Security and CPTED Report

Project Address: 216-238 Keira St, 221-291 Crown Street and
86-90 Burelli Street, Wollongong, NSW
2500

Report Ref: 390844-Wollongong Developments No.8-
CPTED-Report-RevK

Date: 26 June 2026

Figure 8-2- Atchinson Street East to West Link

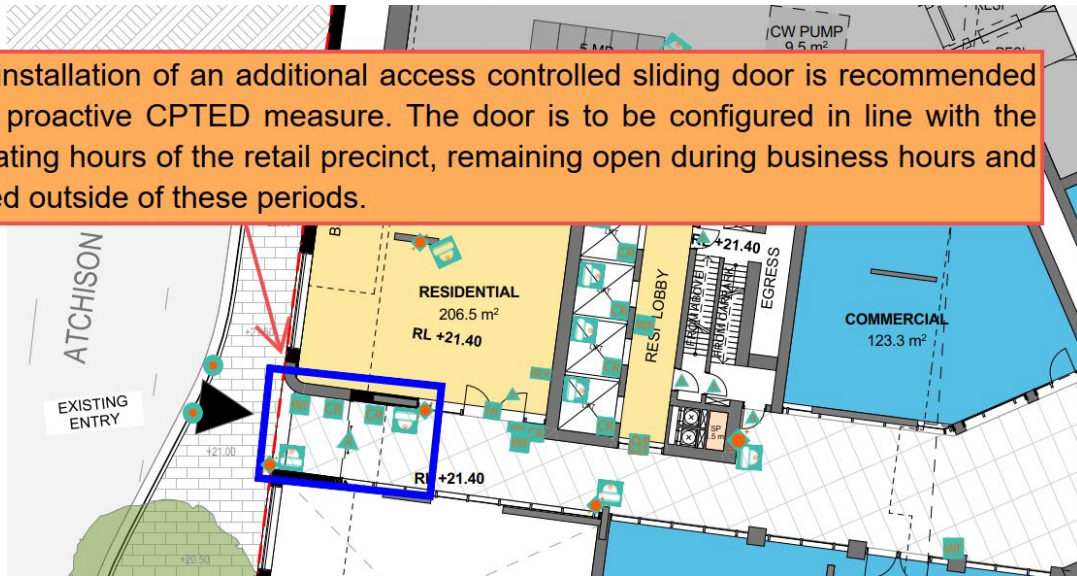
As illustrated in Figure 8-2 Figure 8-3 and Figure 8-4, it is recommended that a series of electronically controlled sliding doors be introduced along the east to west pedestrian link to support a coordinated security response. These doors are intended to maintain an open and continuous pedestrian connection during retail operating hours, while enabling controlled access outside of these periods. Each door should remain open during business hours and be secured after hours, with access restricted to authorised users via dual card readers on both sides aligned with CPTED principles.

All doors are to be integrated with reed switches to monitor their open and closed status, supported by video surveillance and appropriate security lighting to deter unauthorised access and assist with incident verification. Independent access control measures should also be implemented beyond each door to maintain separation between residential, retail and commercial areas. Collectively, these proposed measures provide a consistent approach to access management while preserving the design intent of a clear and unobstructed through site link.

Figure 8-4- Lower Ground Electronic Sliding Door

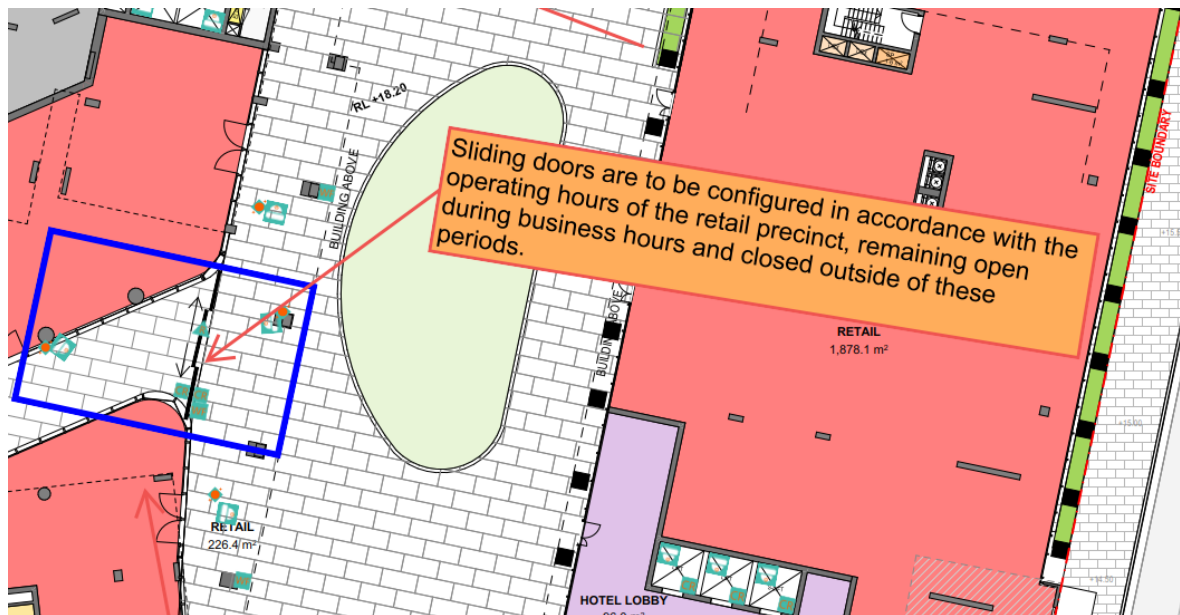
The installation of an additional access controlled sliding door is recommended as a proactive CPTED measure. The door is to be configured in line with the operating hours of the retail precinct, remaining open during business hours and closed outside of these periods.

Figure 8-2 - DtS Re-entry from Fire Isolated Exits as per D3D27(2)(a).

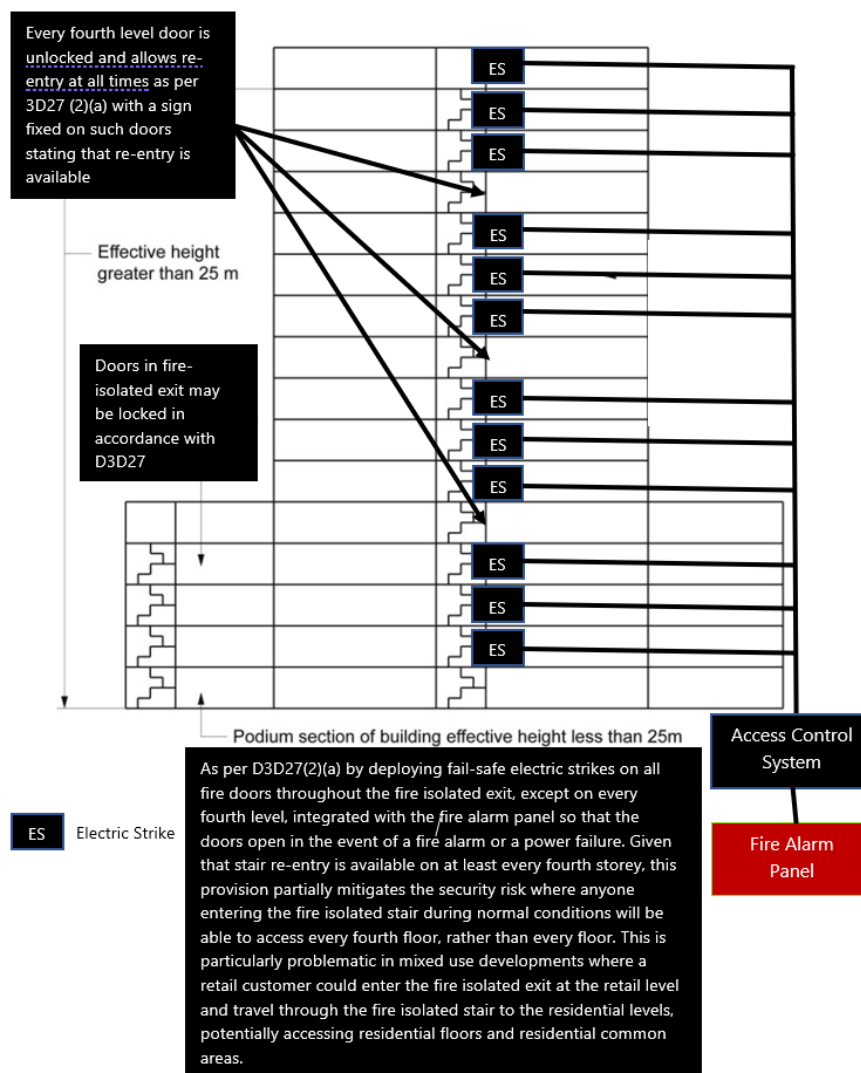
- A fail-safe electronic door release system linked to the fire alarm, ensuring automatic unlocking during emergencies.
- Under D3D27(2)(a), by deploying fail-safe electric strikes on all fire doors throughout the fire isolated exits, except on every **fourth** floor ensures that the fail-safe devices fitted to the fire exit doors automatically unlock the door upon activation of a fire alarm. See Figure 8
- Additionally, D3D27(2)(b) emphasises a more risk-mitigated approach by implementing fail-safe electric strikes on doors at **all** levels within the fire-isolated stairs, as well as installing intercoms and appropriate signage inside the fire stairwell. See Figure 8.

- Applies to buildings over 25m in height
- Relevant to fire-isolated stairwells servicing these heights
- Install a fail-safe electronic door release system linked to the fire alarm for automatic unlocking.
- Designer can implement either design for implementing fail-safe electric strikes throughout stairwells as Figure 8-2 and Figure 8-3 highlight.

Drawing Name
Basement 02

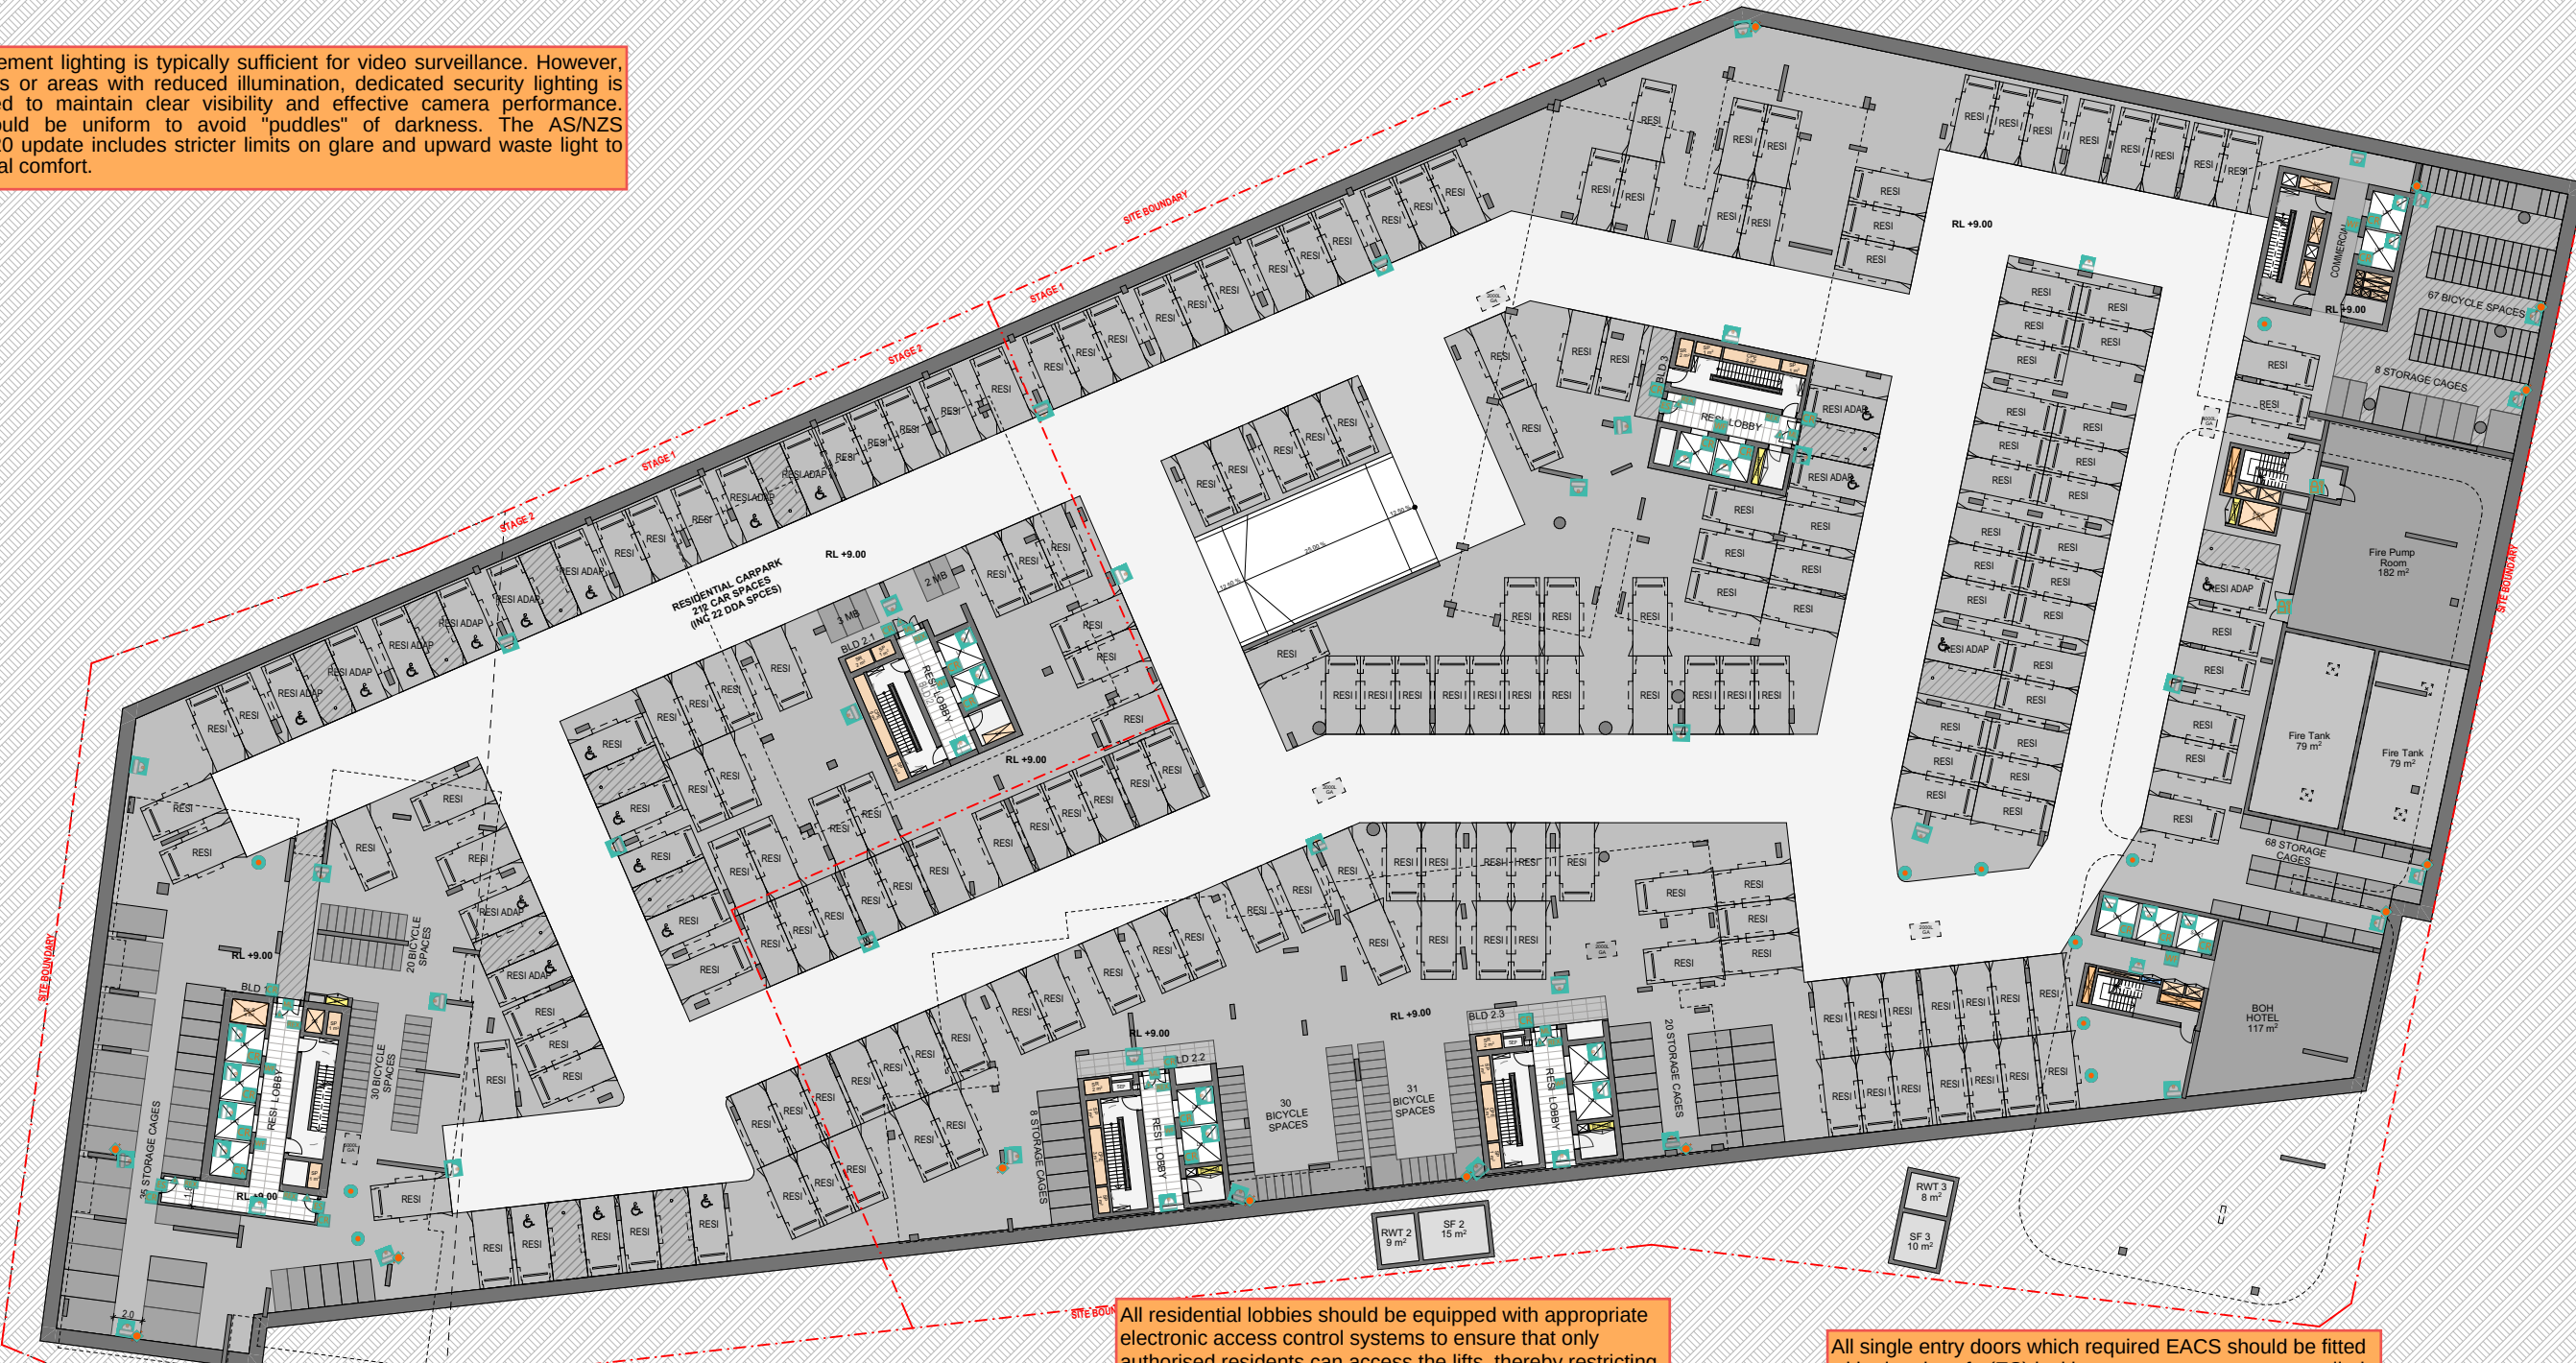
Vehicle Approach Speed Management (VASM) measures are recommended within larger car park environments to regulate vehicle speeds. This is particularly important in areas that experience high levels of pedestrian activity, including locations adjacent to storage areas, lift lobbies and other internal access points, where reduced vehicle speeds are critical to maintaining safety and minimising risk.

Video surveillance shall be positioned to continuously monitor vehicle number plates and adjacent pedestrian routes, supporting effective oversight of vehicle and pedestrian movement within the car park.

General basement lighting is typically sufficient for video surveillance. However, in blind spots or areas with reduced illumination, dedicated security lighting is recommended to maintain clear visibility and effective camera performance. Lighting should be uniform to avoid "puddles" of darkness. The AS/NZS 1158.3.1:2020 update includes stricter limits on glare and upward waste light to improve visual comfort.

NSW Police recommend the installation of 'Park Smarter' signage advising motorists to secure their vehicles and remove valuables from view.

Drawing Name
Level 2 Plan

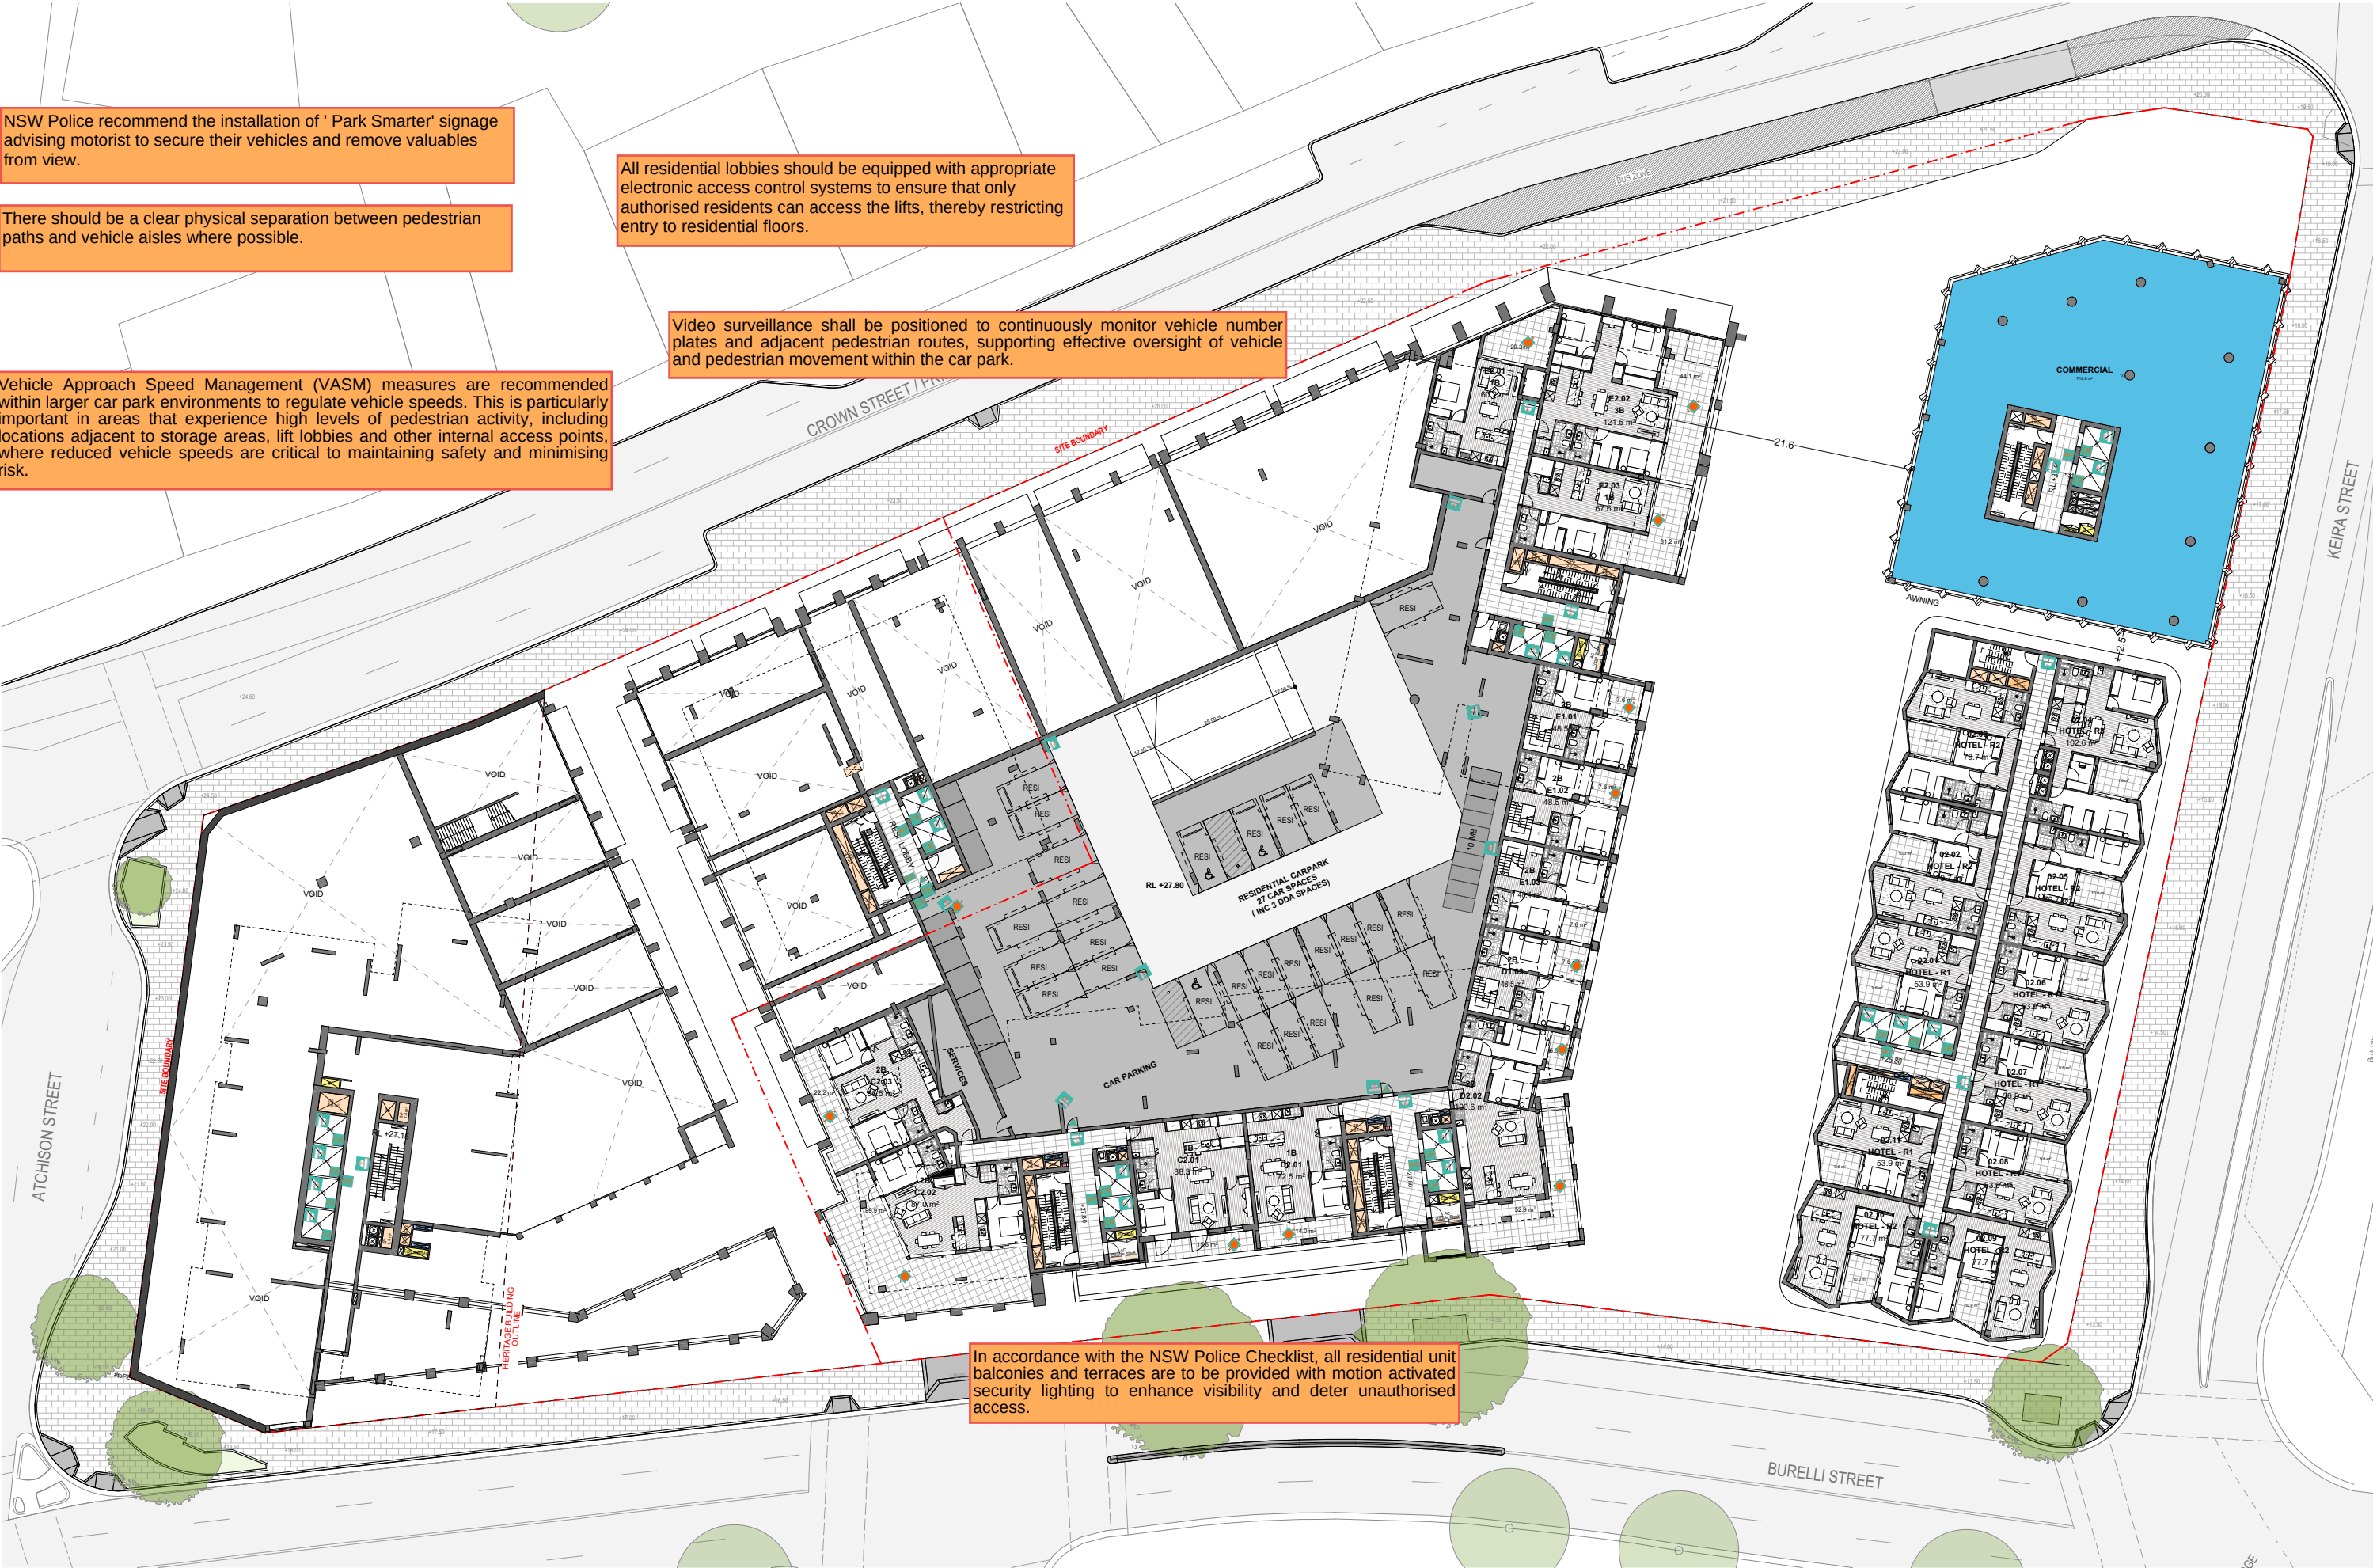
There should be a clear physical separation between pedestrian paths and vehicle aisles where possible.

Vehicle Approach Speed Management (VASM) measures are recommended within larger car park environments to regulate vehicle speeds. This is particularly important in areas that experience high levels of pedestrian activity, including locations adjacent to storage areas, lift lobbies and other internal access points, where reduced vehicle speeds are critical to maintaining safety and minimising risk.
